To: Chris Ogle, Benchmark Engineering, Inc.
From: Robert Bricker, CPSS, REHS/R.S., Environmental Sanitarian II
Well and Septic Program
RE: 13000 Wainwright Road, subdivision Perc Cert, amended comments

RE: 13000 Wainwright Road, subdivision Perc Cert, amended comments

OWNER:		PROJECT:	
EML MANAGEMENT, LLC 3 ASHCROFT WAY REISTERSTOWN, MARYLAND 21136		13000 WAINWRIGHT ROAD	
LOCATION:		THE MAP-40-000-15 PARCELS-42	
TITLE:		REVISED PERCOLATION CERTIFICATION PLAN	
DATE:		JUNE 2023	
PROJECT NO. 2485		DRAWING NO. 1 OF 1	
DESIGN: CHA/JCO	DRAFT: JCO	SCALE: AS SHOWN

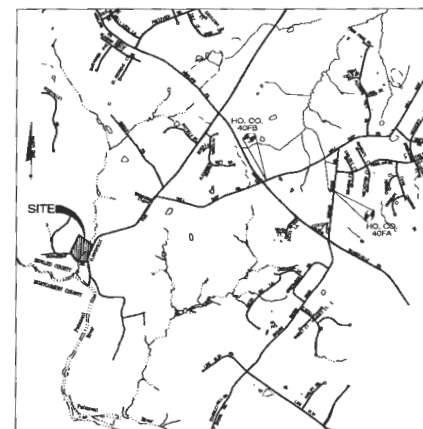
The following additions, deletions, and/or corrections are required, and if indicated, supercede comments of May 29.

1. A small portion of the proposed septic reserve area (near perc test #3) on proposed 'Lot 1' is within 25 feet of slopes > 25%.
2. Delete Note #6.
3. Add this Note:
All wells shall be drilled prior to final plat recordation. It is the developer's responsibility to schedule the well drilling prior to final plat submission. It will not be considered "government delay" if the well drilling holds up Health Department signature of the Record Plat.

4. Edit Note #8 as follows
Existing wells, septic systems, and sewage disposal areas within 100' of the property and those wells within 200' down-gradient of existing or proposed septic systems or sewage disposal areas have been shown. Any septic system drainfield or septic reserve area within 200 feet up-gradient of proposed wells or wellboxes are shown.

5. Edit Note #9 as follows:
The purpose of this plan is to revise a previously approved percolation certification plan (7/16/98) by changing proposed lot lines, relocating a Use-In –Common (re: Ingress/Egress) Easement, and adding alternate wells and wellbox locations.

6. Edit Note #11 as follows (supercedes May 29 comment):
The existing drilled well (HO-94-0210) on proposed 'Lot 2' is to be sealed by a Licensed Well Driller, and the Well Abandonment Report received by the Health Department, prior to Record Plat submittal.

7. Add this Note:
The pit well in front of the existing house (identified as "Abandoned Well") on proposed 'Lot 2' is to be sealed by a Licensed Well Driller, and the Well Abandonment Report received by the Health Department, prior to Record Plat submittal.

8. Edit Note #12 as follows (supercedes May 29 comment):
The septic system serving the existing residence on proposed 'Lot 2' is to be abandoned and replaced prior to Record Plat submittal. Photos and a contractors report will be submitted to the Health Department showing and indicating proper abandonment of the existing septic tank and the existing dry well.

9. On proposed 'Lot 2', there is a structure about 45 feet long identified as "Ex. Structure To Be Removed". Correctly identify this structure as a : "Semi-truck trailer To Be Removed".

10. There are two auxiliary structures near the existing house on [proposed 'Lot 2'. Locate these two structures on the plan and identify whether what each is and whether it is 'To Remain' or 'To Be Removed'.

11. There is a utility easement crossing the subject property in the area proposed as 'Lot 2' and 'Lot 3'. Show the location of the utility easement and the location of the utility pole and the overhead electric line within the easement. Observe that neither a well location not the septic reserve area may occupy the same area as the utility easement.

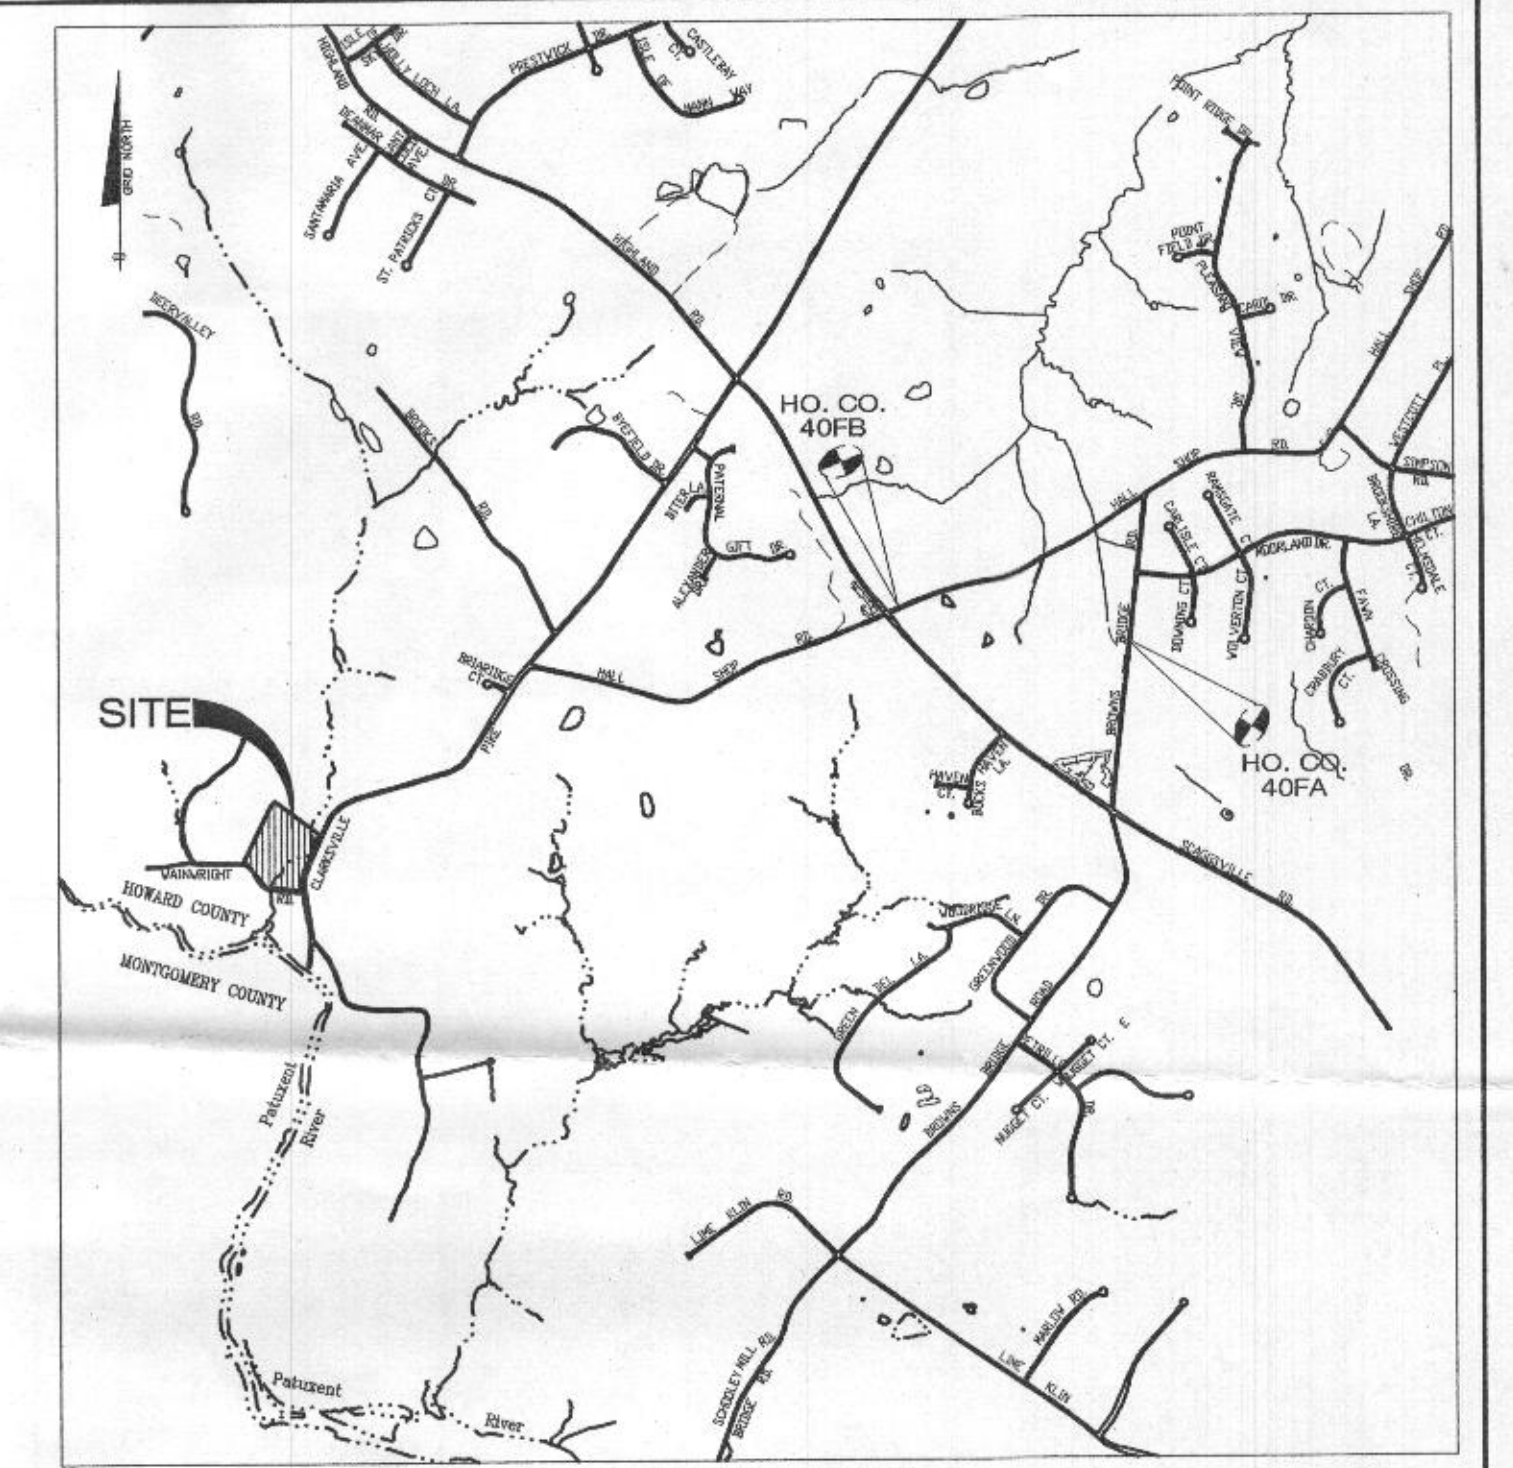
The following adjustments are needed on the plan submitted for comment on June 5.

1. There are small unusable triangles at the 'top' and 'bottom' of the proposed septic reserve on Lot 1. It appears that these can be deleted and the lower boundary of the septic reserve 'squared off' the contour.
2. Similarly on Lot 2, delete the small unusable triangles and extend the septic reserve on contour to the southwest to make up the lost area.
3. On Lot 2, move 'Well #2' to the east a little so that it is not in the drainageway.
4. On Lot 2 add the phrase "To Be Sealed" to the label describing Approx. Abandoned Well, and insert the term "Pit" in the label (as it is a pit well).
5. Correct the label for Approx. Existing Well by replacing the term 'Abandoned' with the term "Sealed".
